HISTORIC PRESERVATION BOARD AGENDA

TUESDAY, MARCH 3, 2020 @ 4:00 PM

Consider a request by Matthew Motz for a Certificate of Appropriateness to enclose a 99 square foot patio located at 706 N 7th Street

After reviewing the request for a Certificate of Appropriateness, COA-2020-85, for the property located at 706 N 7th Street, the following findings of fact have been made:

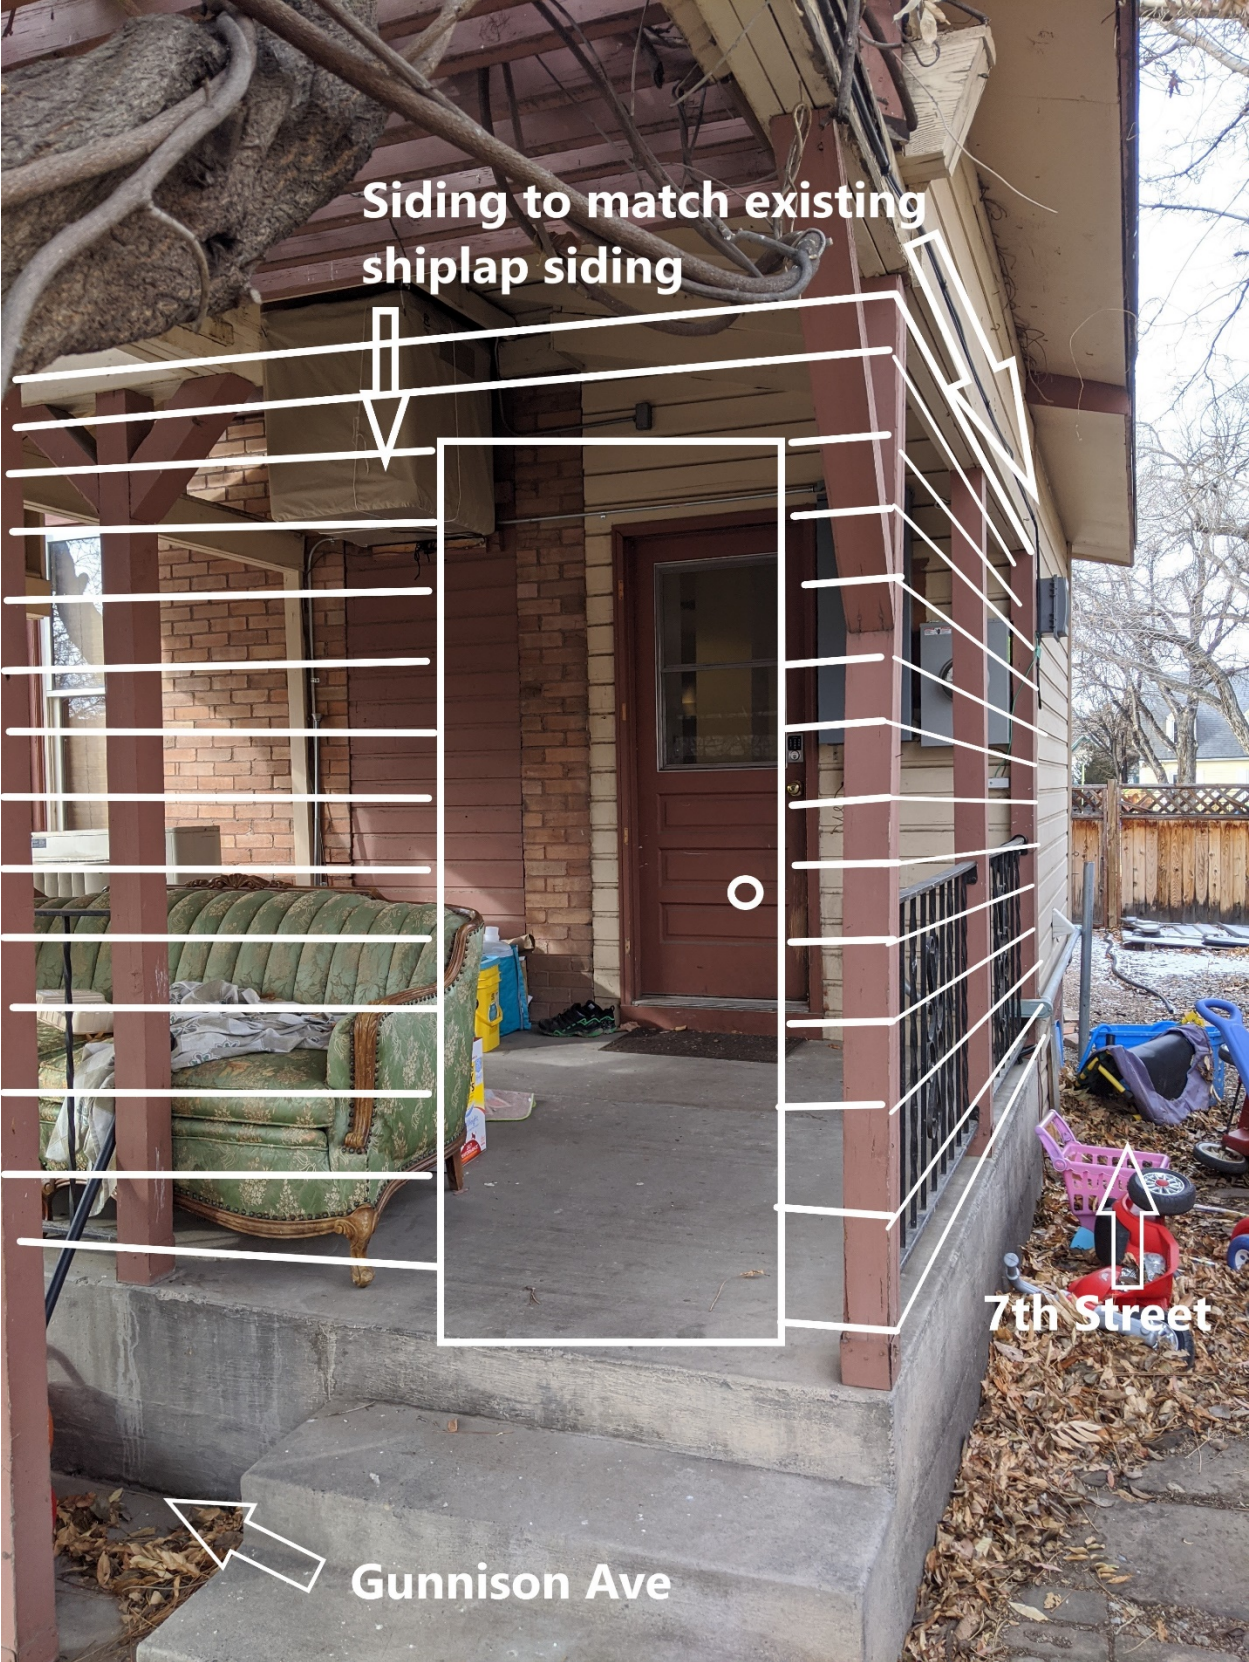
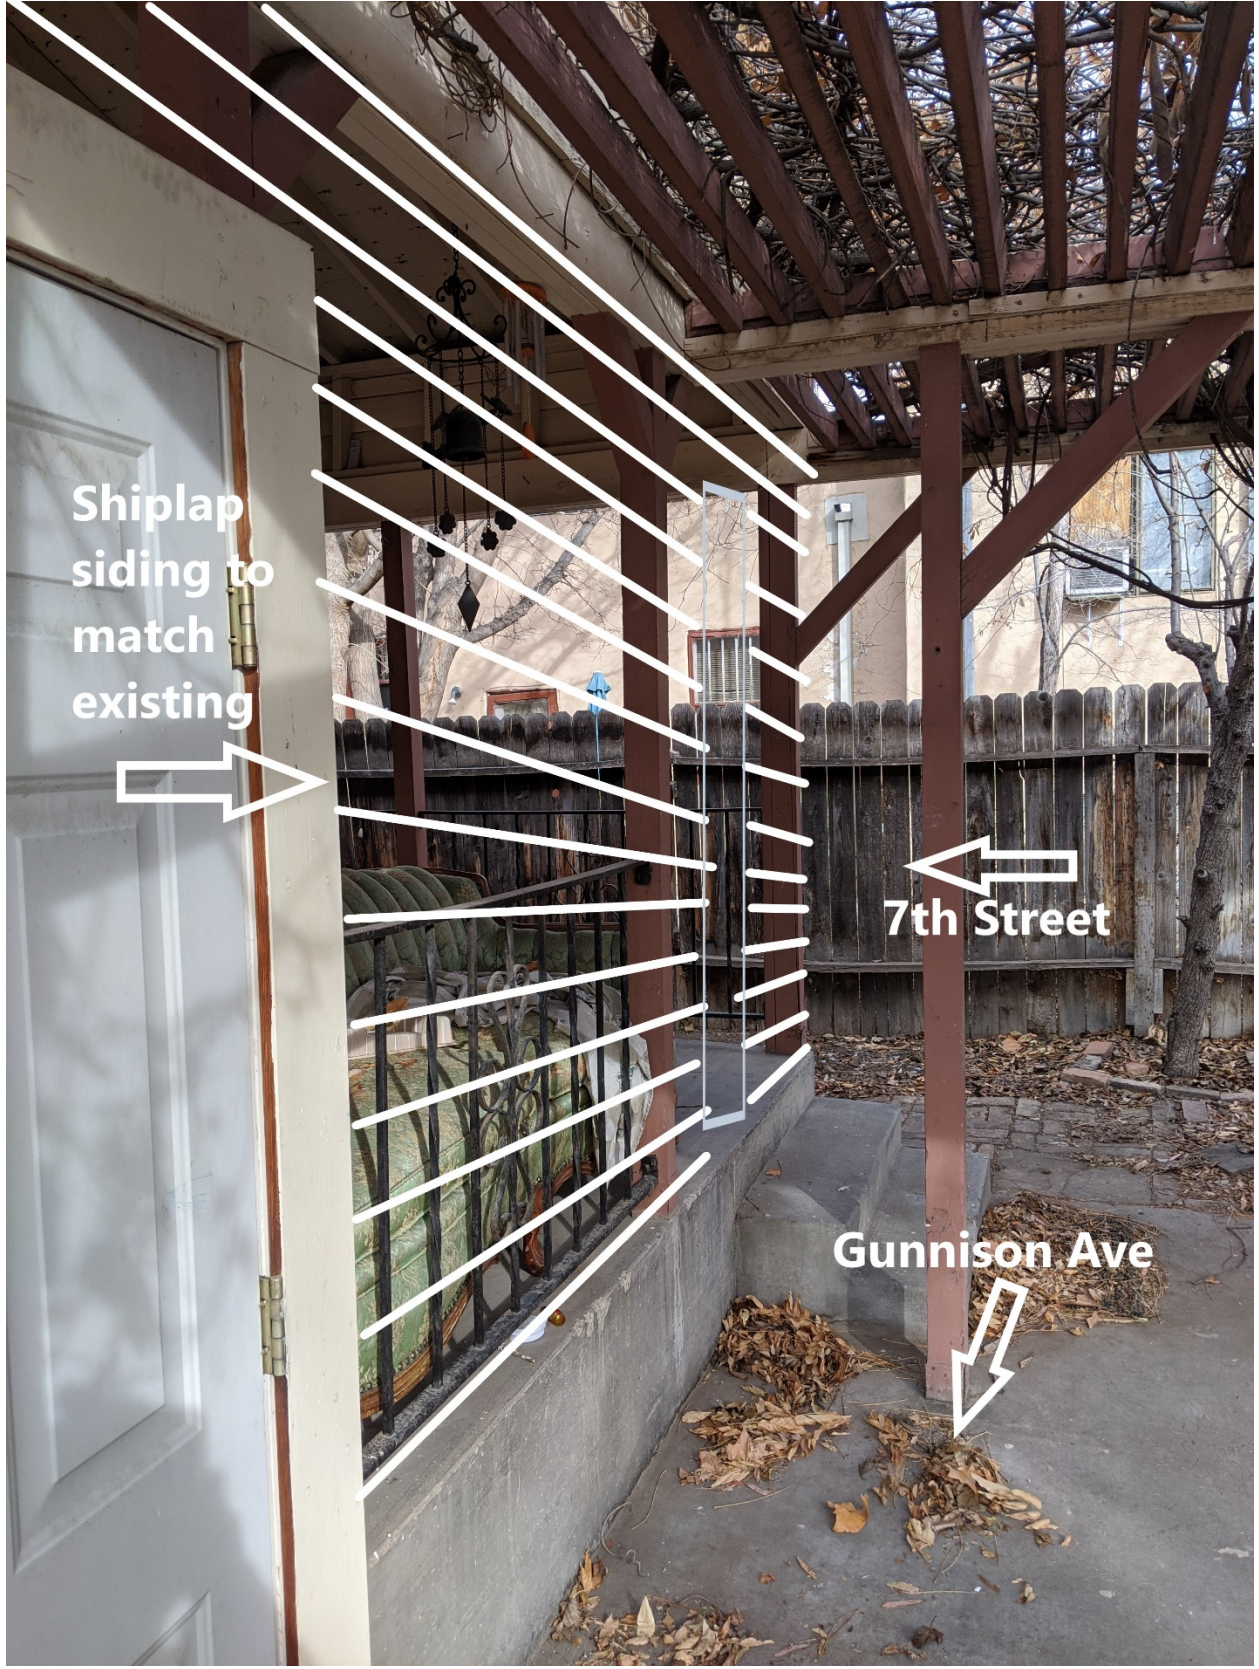
The proposed exterior wall material for this project, shiplap wood siding, matches what is currently present on part of the side and rear yard of the Applicant’s house. Therefore, staff finds that this criterion has been met.

The Applicant proposes to install a new window on the south façade of the enclosed patio and has stated that both the window size and dimensions as well as the window trim will match the adjacent existing window and trim. Therefore, staff finds that these criteria have been met.

The Applicant’s proposed plan shows that windowsills and trim will be replicated, so staff finds that these criteria have been met.
